# UNITED STATES PATENT AND TRADEMARK OFFICE

APPLICATION NO.	FILING DATE	FIRST NAMED INVENTOR	ATTORNEY DOCKET NO.	CONFIRMATION NO.
10/686,439	10/14/2003	Hirofumi Konishi	47434-00053	6874
7590 11/17/2004				
Sung I. Oh, Esq. Squire, Sanders & Dempsey, L.L.P. 14th Floor 801 S. Figueroa Street Los Angeles, CA 90017		EXAMINER JEFFERY, JOHN A		
		ART UNIT PAPER NUMBER		
		3742		
DATE MAILED: 11/17/2004

<b>Office Action Summary</b>	<b>Application No.</b> 10/686,439	<b>Applicant(s)</b> KONISHI, HIROFUMI	
	<b>Examiner</b> John A. Jeffery	<b>Art Unit</b> 3742

## **DETAILED ACTION**

Regarding claims 26 and 27, note "outer pipe" 32a and coaxial "inner pipe" with flange illustrated below in a reproduction of Fig. 6 of EP536472:

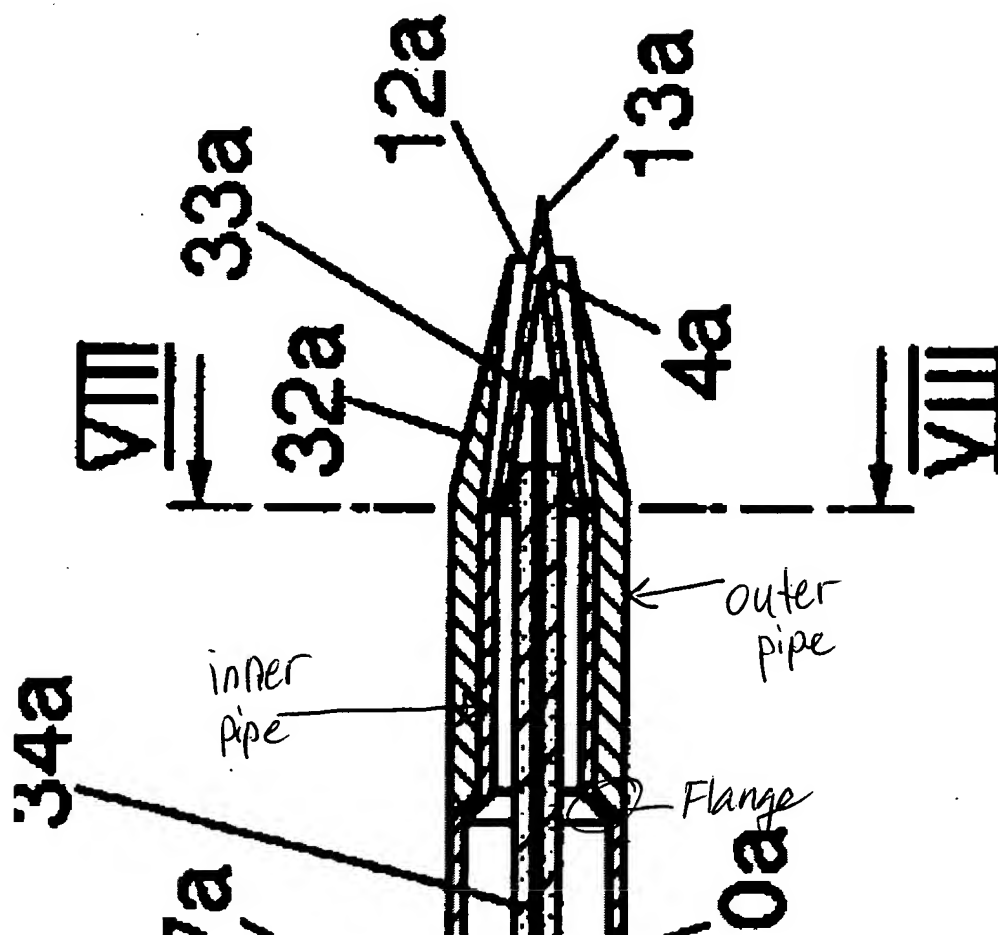
Claims 3, 10, 26, 27, 30, and 38 are rejected under 35 U.S.C. 103(a) as being unpatentable over Fortune (US 5,483,040) or JP2001-347369 in view of EP536472. The claims differ from the previously cited prior art in calling for a heating part partially disposed within the tip. But providing heating portions and sensors within tip portions of soldering irons is well known in the art. EP536472, for example, provides a "heating part" 3a that heats the tip and temperature sensor 33a disposed within the tip portion 20. See Fig. 6. Such a structure not only more quickly heats the tip by apply heat directly to the tip, it also more accurately senses the tip temperature by locating the sensor adjacent the tip. In view of EP536472, it would have been obvious to one of ordinary skill in the art to provide a heating part and sensor at least partially within the tip in the previously described apparatus to not only more quickly heat the tip by concentrating heat at the tip, but also more accurately sense the tip temperature by locating the sensor adjacent the tip.

In view of EP536472, it would have been obvious to one of ordinary skill in the art to provide an outer and inner pipe structure for the exhaust pipe of the previously described apparatus to create a narrow circumferential airflow path adjacent the soldering tip.
